ADDENDUM NO. 1

CSP# 207702

**Org # 194 – K.B. Polk Center for Academically Talented & Gifted -
Renovation**

20 December 2024

SHEET NUMBER A0.11

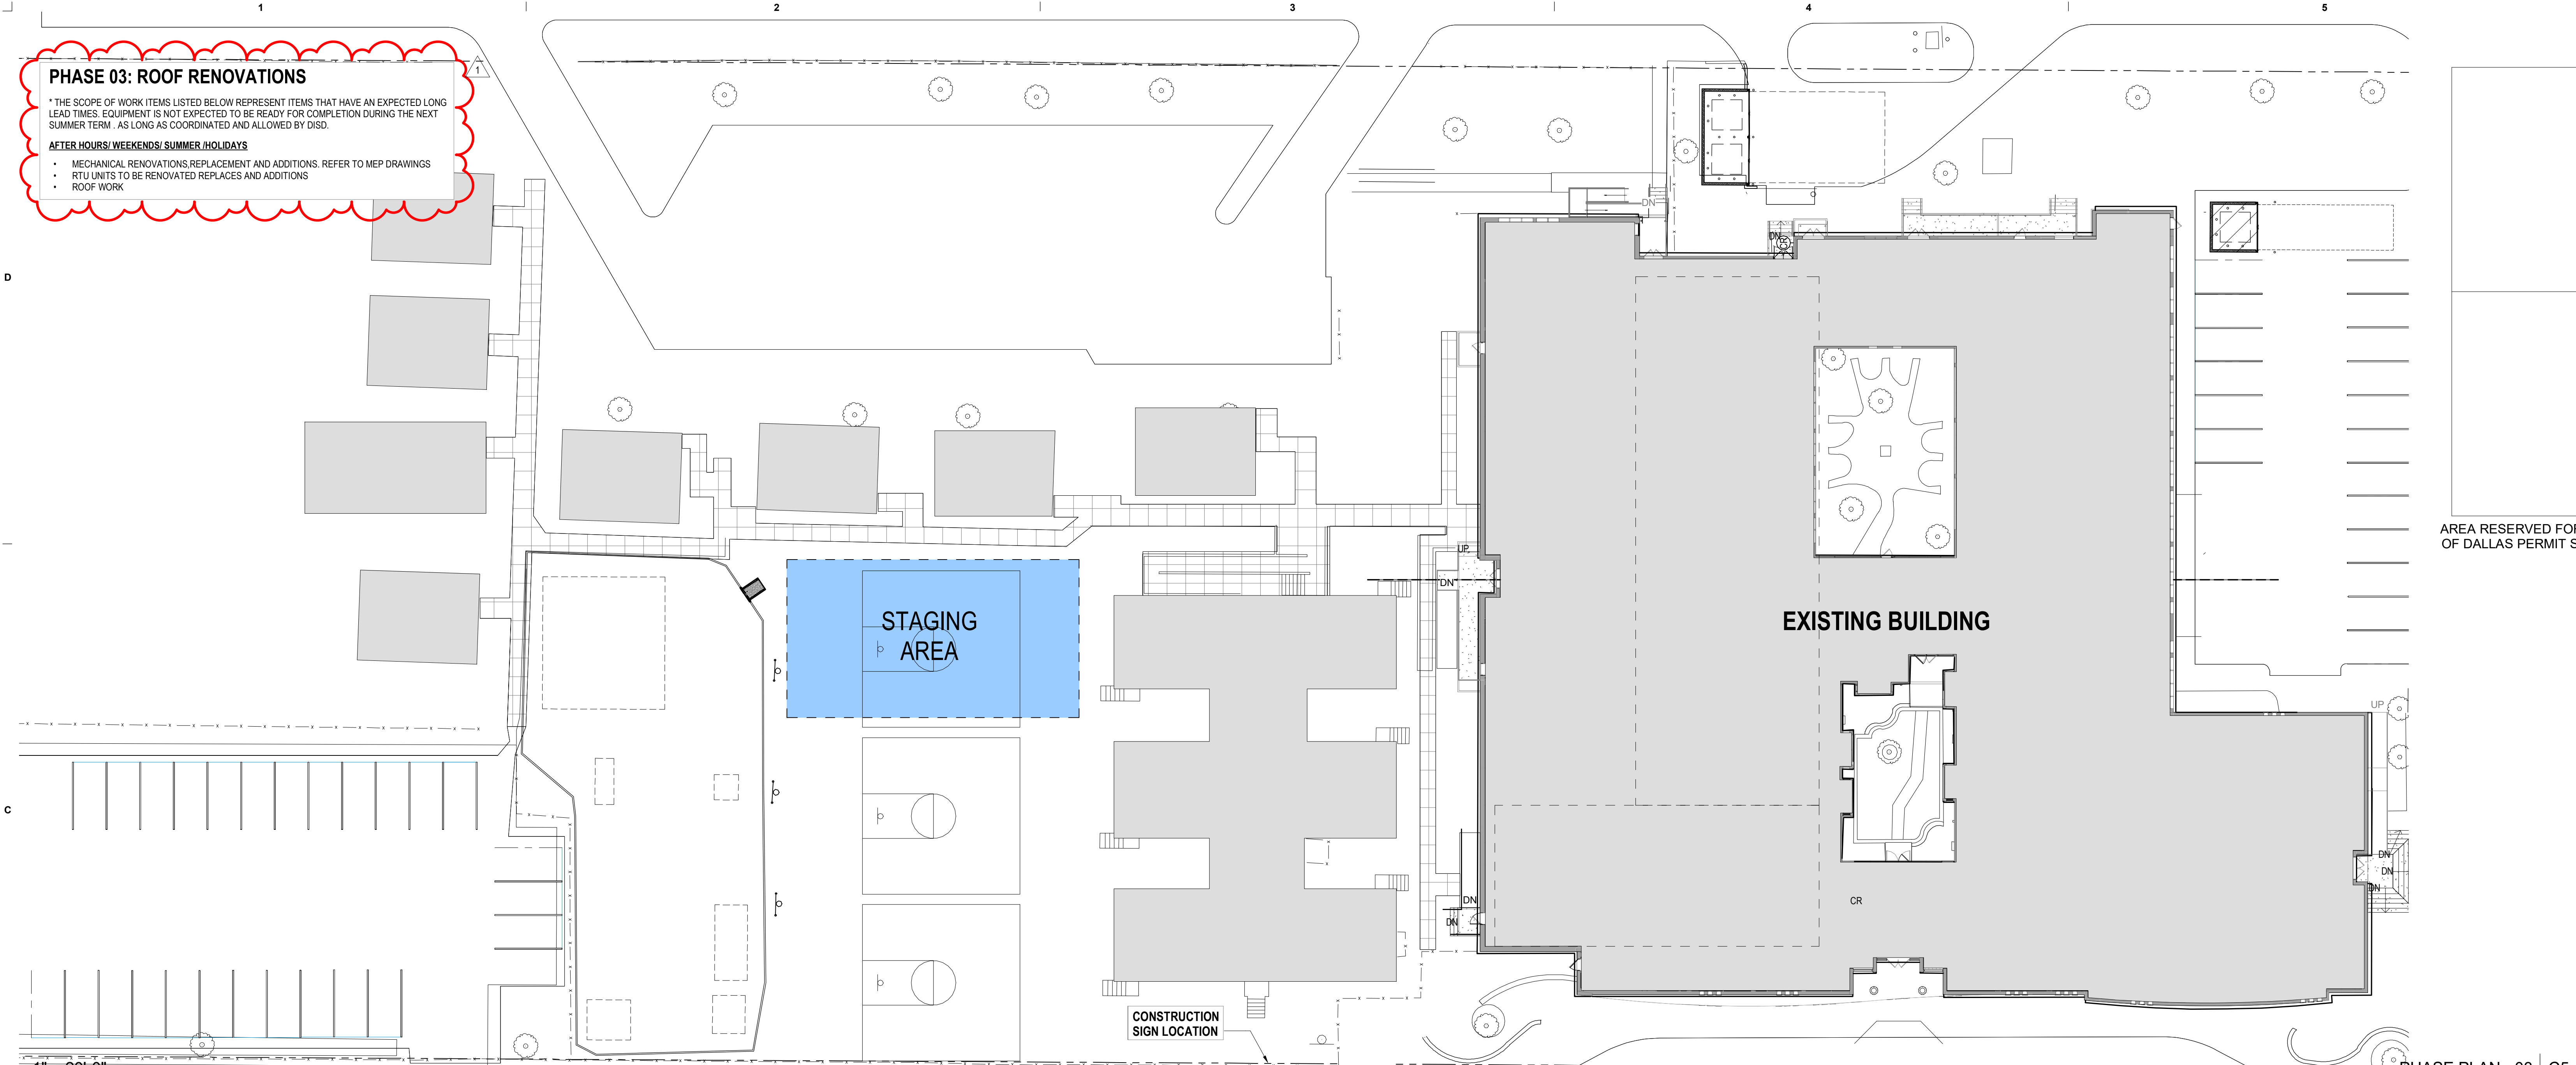
- **Sheet A0.11 – Replace sheet with the revised attached A0.11 ABBREVIATIONS AND SHEET INDEX**
 - Revised sheet notes and scope per attached
- **Sheet A0.12 – Replace sheet with the revised attached A0.12 PHASING PLAN**
 - Revised sheet notes and scope per attached sheet.
- **Sheet A1.20 - Replace sheet with the revised attached A1.20 SITE PLAN**
 - Revised sheet notes and scope per attached sheet.
- **Sheet M3.01 – Replace sheet with the revised attached M3.01 LEVEL 1 MECHANICAL OVERALL PLAN**
 - Revised sheet notes and scope per attached sheet.
- **Sheet M10.01 – Replace sheet with the revised attached M10.01 - MECHANICAL SCHEDULES**
 - Revised sheet notes and scope per attached sheet.

A1.20

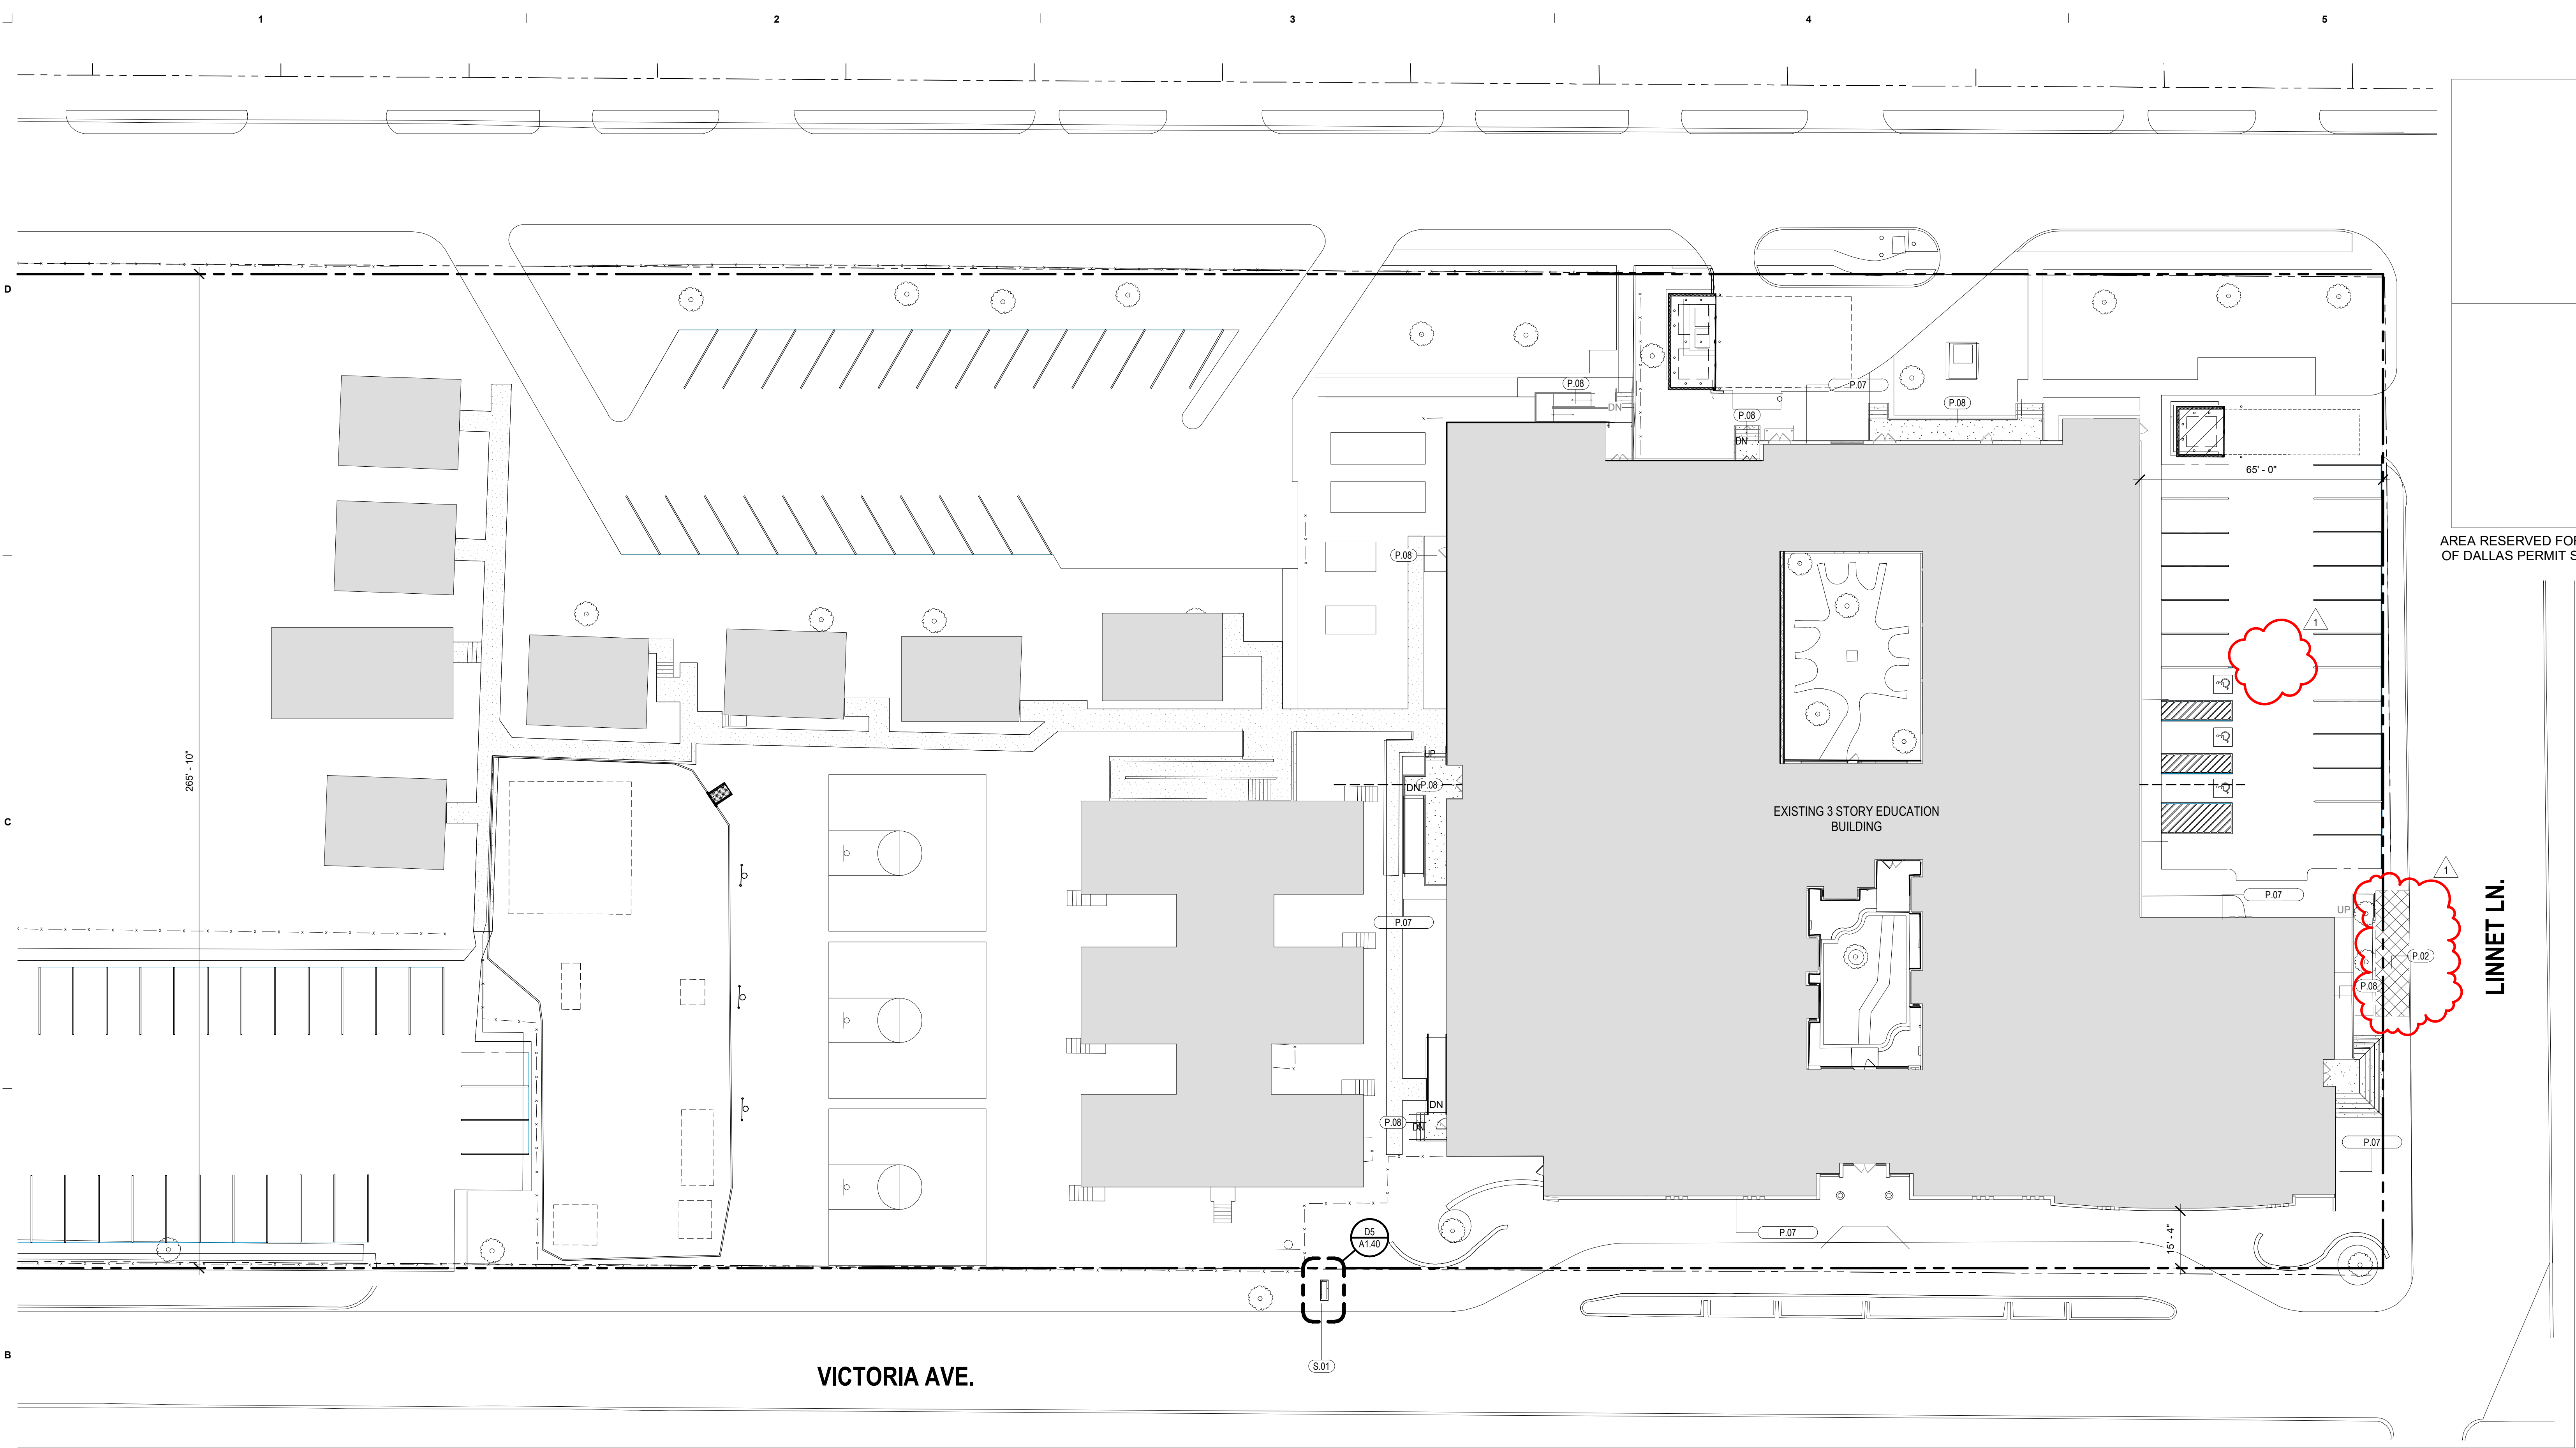
- **Question: Is the abatement under the GC scope?**
 - Response: Yes, please refer to the Haz Mat Task 1 report under Volume 2 Specs for more details.
- **Question: Please provide more information regarding the Alternate #2 Sidewalk replacements including specifications, and locations. Also, on A1.20, Keynote P.02 shows a parking area as part of the sidewalk replacement. Please advise.**

- Response: The extent of replacement of sidewalk is clarified in sheet A1.20. Revised sheet is attached to the addendum.

SHEET NUMBER
P4.01

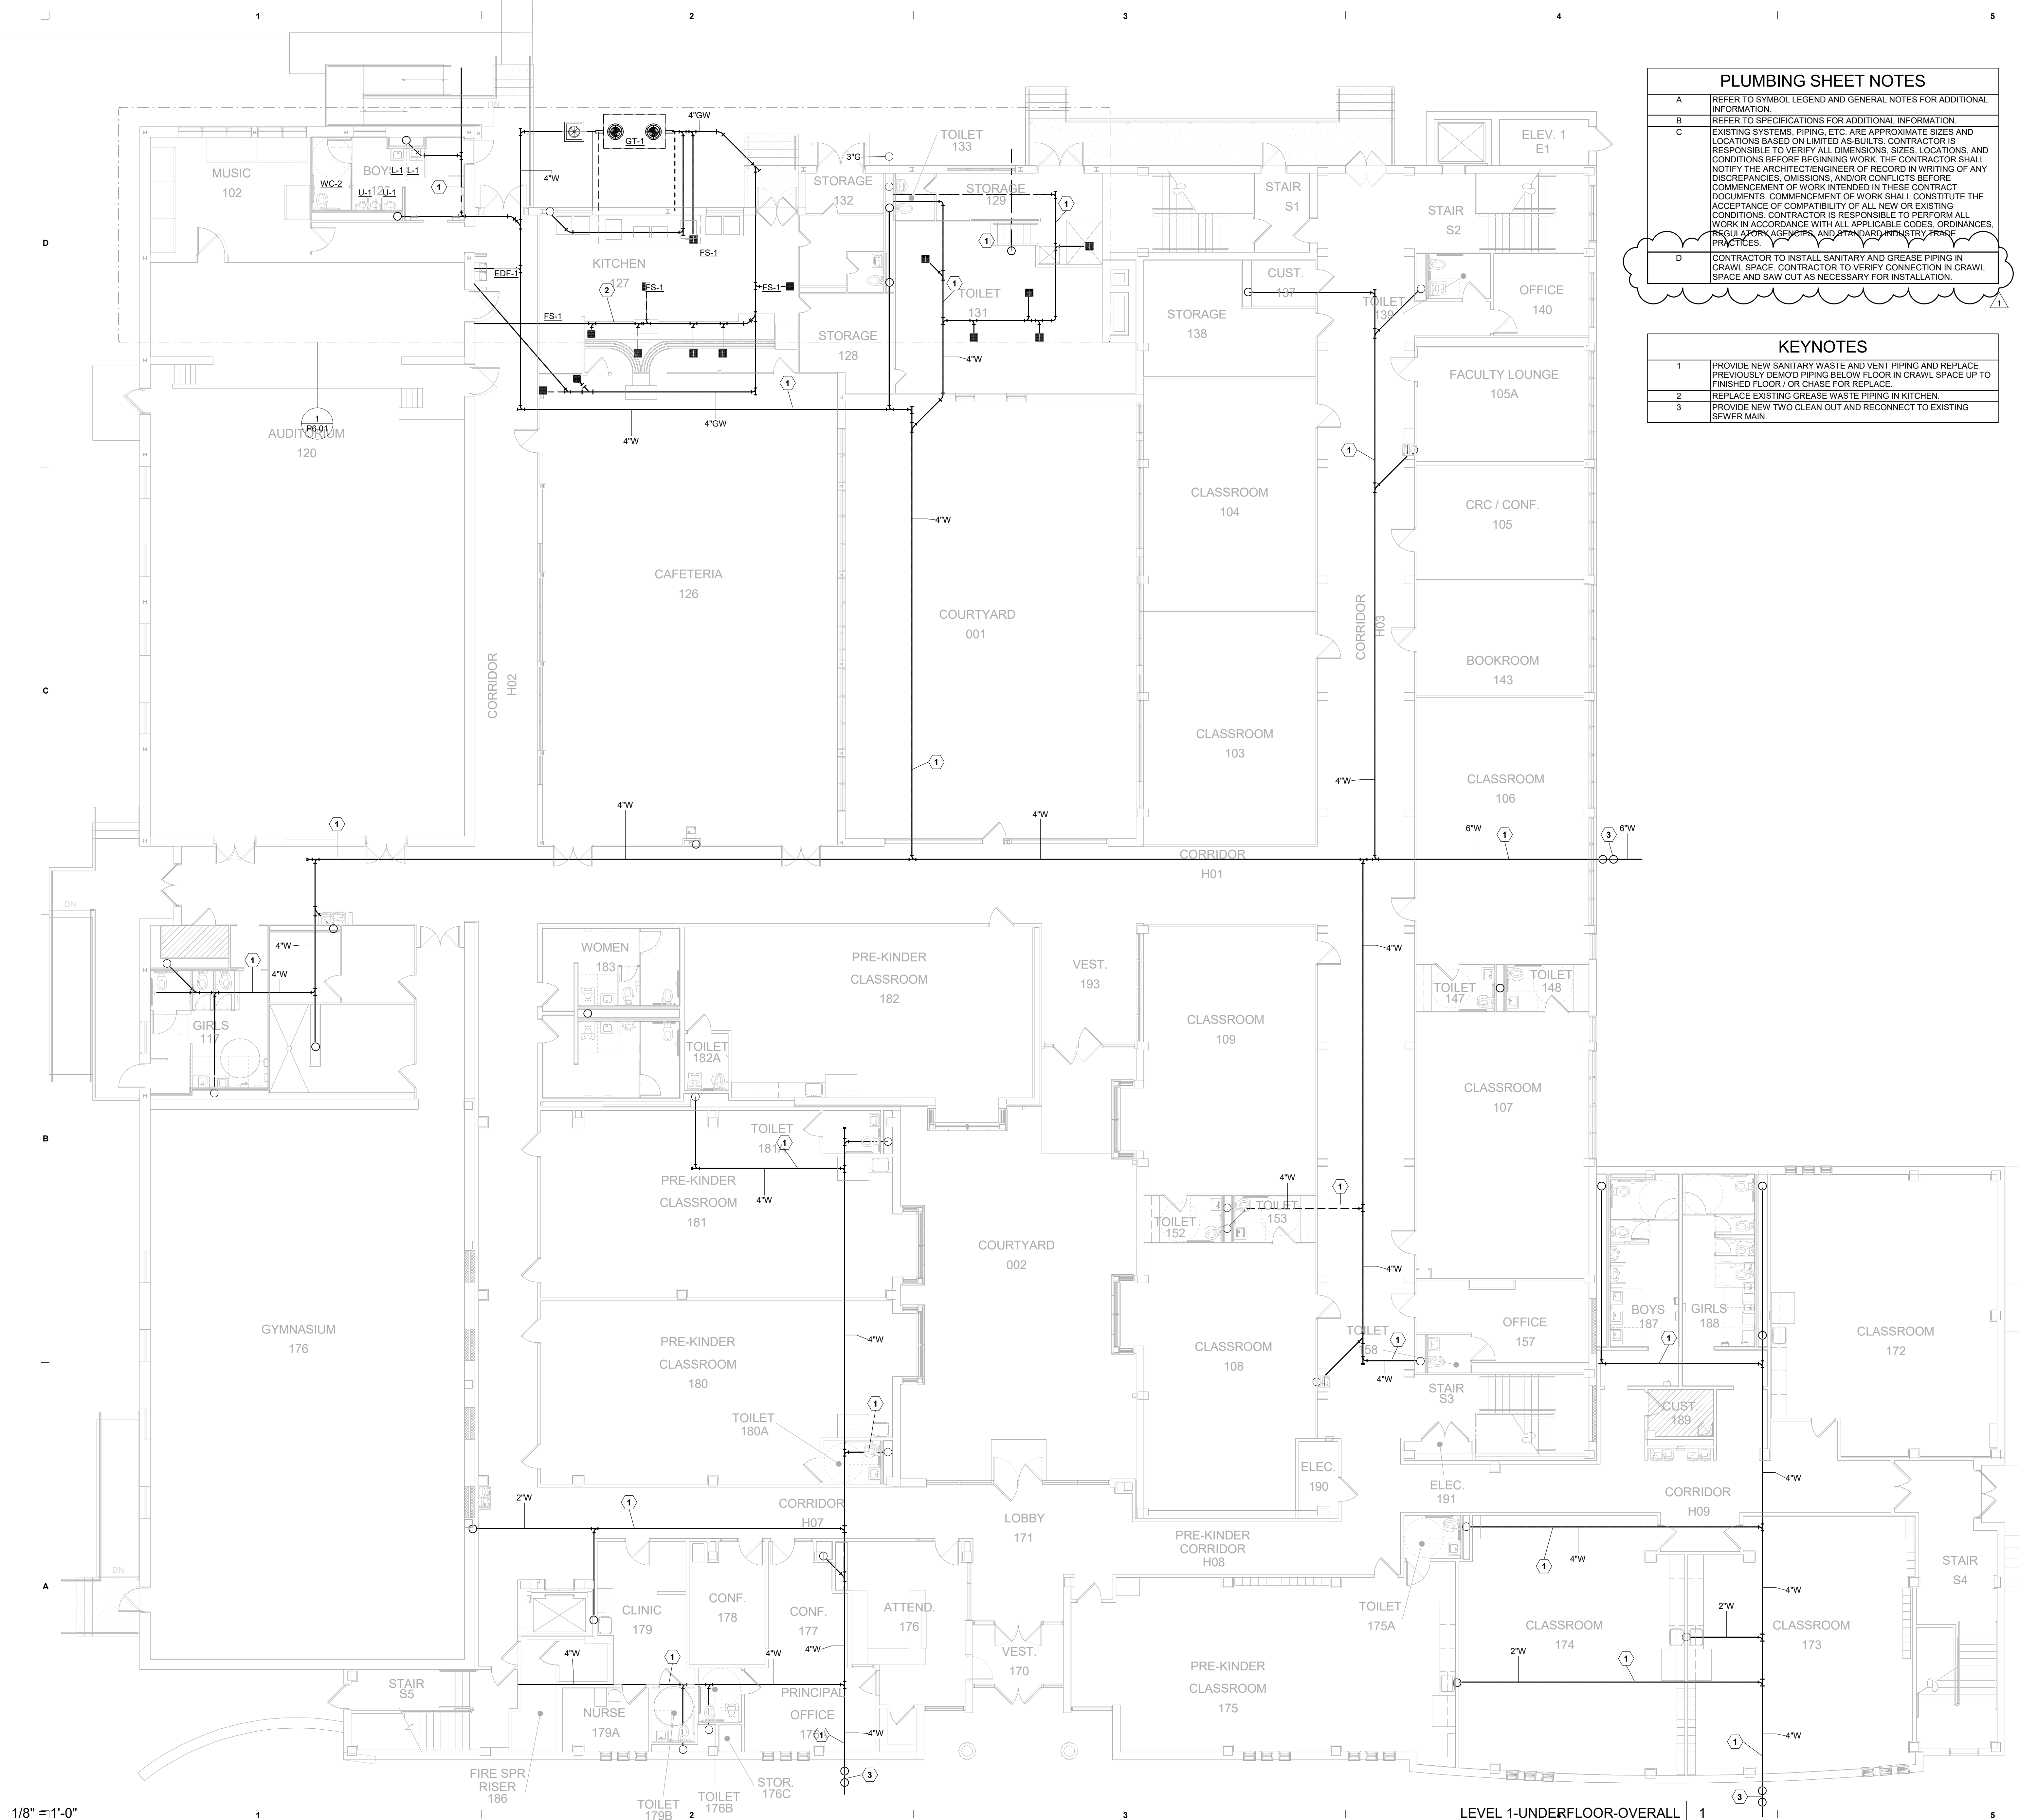
- **Question: On P6.01 Keynote #6 says to replace existing grease waste piping in the kitchen. Are these lines in a crawlspace or will slab saw cutting be required?**
 - Response: To address the keynote #6 on sheet P6.01, refer to revised sheet P4.01 attached to this addendum.

- **Sheet P4.01 – Replace sheet with the revised attached P4.01 PLUMBING UNDERFLOOR – LEVEL 1 OVERALL PLAN**
 - Revised sheet notes and scope per attached sheet.
